Project	IEEE 802.16 Broadband Wireless Access Working Group < http://ieee802.org/16 >	
Title	Clarification on vertically encoded MIMO	
Date Submitted	2005-01-22	
Source(s)	Qinghua Li, Xintian Eddie Lin, Ada Poon, Alexei Davydov, Nageen Himayat, Minnie Ho, Sumeet Sandhu, Uri Perlmutter, Yuval Lomnitz, Randall Schwartz, Jose Puthenkulam Intel Corporation	qinghua.li@intel.com Voice: +1-408-765-9698
Re:		
Abstract		
Purpose	Adoption of proposed changes into P802.16e Crossed out indicates deleted text, <u>underlined blue indicates new text change to the Standard</u>	
Notice	This document has been prepared to assist IEEE 802.16. It is offered as a basis for discussion and is not binding on the contributing individual(s) or organization(s). The material in this document is subject to change in form and content after further study. The contributor(s) reserve(s) the right to add, amend or withdraw material contained herein.

Clarification on Vertically Encoded MIMO

Figure 3 Proposed structure for vertically encoded MIMO.

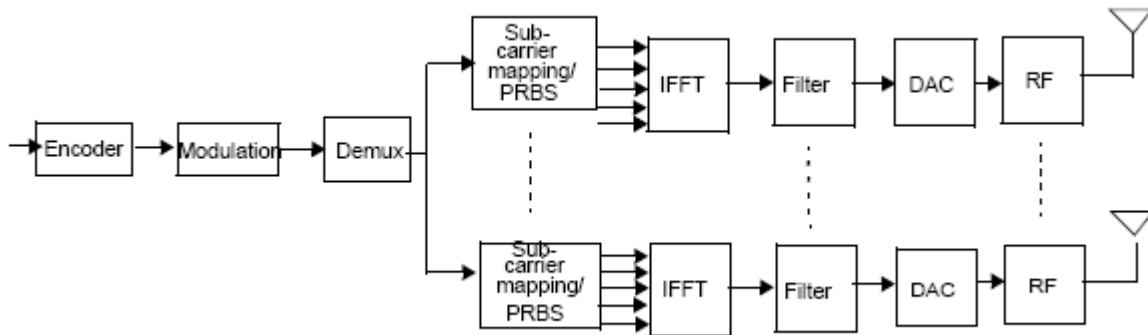
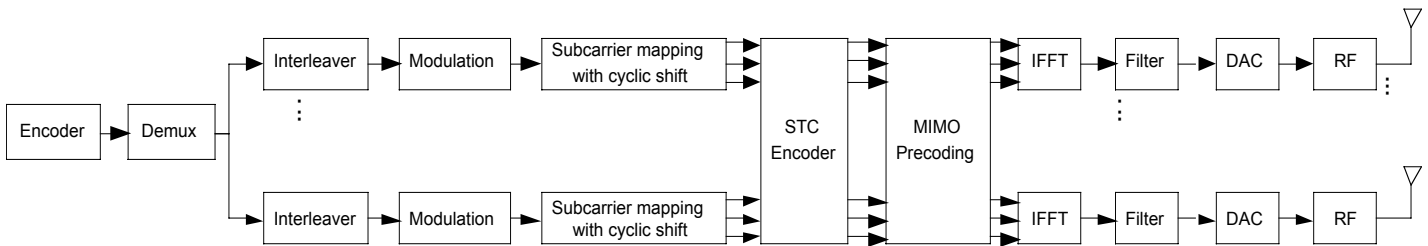
On page 336, D5a, there is an exemplary figure for vertically encoded MIMO, which is shown in Figure 1. The major disadvantages of this structure are as follows. First, new interleavers are needed to be defined for the increased payload sizes due to parallel spatial channels. For example, the interleaver size at the output of encoder needs to be doubled for two spatial channels. Second, frequency diversity is not maximized because the subchannel allocation for each spatial stream is the same. For example, one FEC block is interleaved and mapped into QAM symbols. The QAM symbols are alternately assigned to two subchannel blocks on two spatial channels by the demux. Because the subchannel allocation is exactly the same on both spatial channels, both subchannels are on the same subcarriers. This means that the FEC block is placed on the same physical subcarriers on both spatial channels. This limitation reduces the frequency diversity if the subchannel doesn't occupy all subcarriers allocated for the user. Frequency diversity can be improved by allowing the logical subchannels on different spatial channels to be placed on different sets of physical subcarriers. Finally, the structure in Figure 1 doesn't support adaptive bit loading because all code bits are mapped to the same modulation constellation before demux. The performance of closed loop is maximized when different modulation orders are employed for different spatial streams. The signal qualities on spatial channels can be different by more than 9 dB, which can not be compensated by FEC codes, and the weakest spatial channel dominates the performance although there is excess signal power in the strong spatial channels.

We propose slight modifications of the structure in Figure 1. The new structure supports open loop, closed loop, UBL, and ABL, as shown in Figure 3. It doesn't need to define new interleavers for MIMO and employs legacy interleavers designed for single-input single-output systems. The demux in Figure 1 is enhanced to support ABL and a cyclic shift is added at subcarrier mapping block to maximize frequency diversity. The transmitter works as follows. A block of data bits is first encoded by FEC encoder and the code bits are punctured to achieve a specified code rate. The punctured code bits are distributed to multiple streams according the modulation orders selected for the spatial channels. The distributed bits are interleaved by a legacy interleaver on each channel. The interleaved bits are mapped to QAM symbols and the QAM symbols are mapped to logical subcarriers. The QAM symbols on the logical subcarriers are circularly shifted by $j - 1$ subcarrier for the j -th channel for $j = 1, L, M$. The circular shift allows the physical subchannel allocations on different spatial channels to be different so that frequency diversity is maximized. After the shift, the QAM symbols are STC encoded and may be beamformed and are finally sent. Detailed operations of the demux is depicted next.

The demux extracts bits for M spatial channels one by one in descending order of the channels' modulation order. It first evenly extracts the bits for the spatial channel with the greatest modulation order from the input bit sequence. Namely, the i -th extracted bit is the k -th bit in the original input bit sequence, where

Figure 254a Illustration of vertically encoding for optional zones in DL.

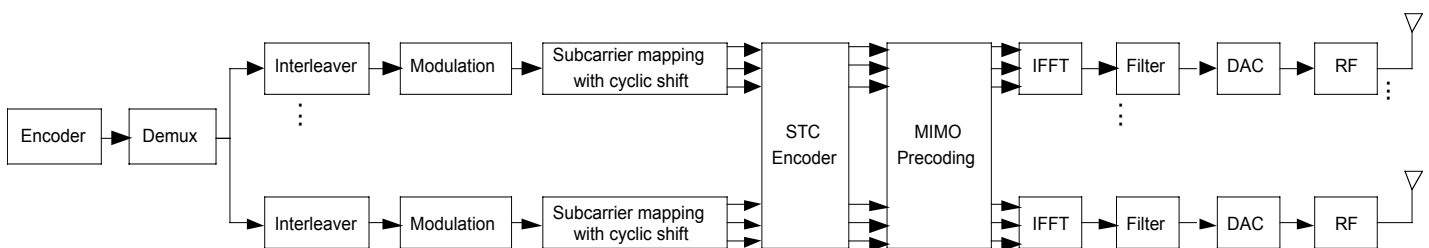
Added section 8.4.8.10 at line 33 on page 362 of [1] as follows

Figure 254a illustrates a transmitter for vertically encoded MIMO, where there are M data streams. The punctured code bits are distributed into M modulation chains by the demultiplexer. The demultiplexer extracts bits for the chains one by one from its input bit sequence. The bits to the chain with higher modulation order are extracted before those with lower modulation order. Denote the number of bits per subcarrier on the j -th chain as L_j , where $L_1 \geq L_2 \geq \dots \geq L_M$. The demultiplexer first extracts the bits for the chain with the greatest modulation order from as follows. The i -th extracted

bit is the k -th bit in the original input bit sequence, where $k = \text{round}\left(\frac{i}{L_1} \sum_{j=1}^M L_j\right)$. For the p -th chain, the i -th extracted

bit is the k -th bit in the remaining bits after the extractions for the previous $p-1$ chains, where $k = \text{round}\left(\frac{i}{L_p} \sum_{j=p}^M L_j\right)$.

Each chain interleaves and modulates the distributed bits using the interleaving schemes specified for SISO transmission. After mapped to logical subcarriers, the modulated symbols are circularly shifted by $j-1$ logical subcarriers for the j -th chain for $j = 1, 2, \dots, M$.
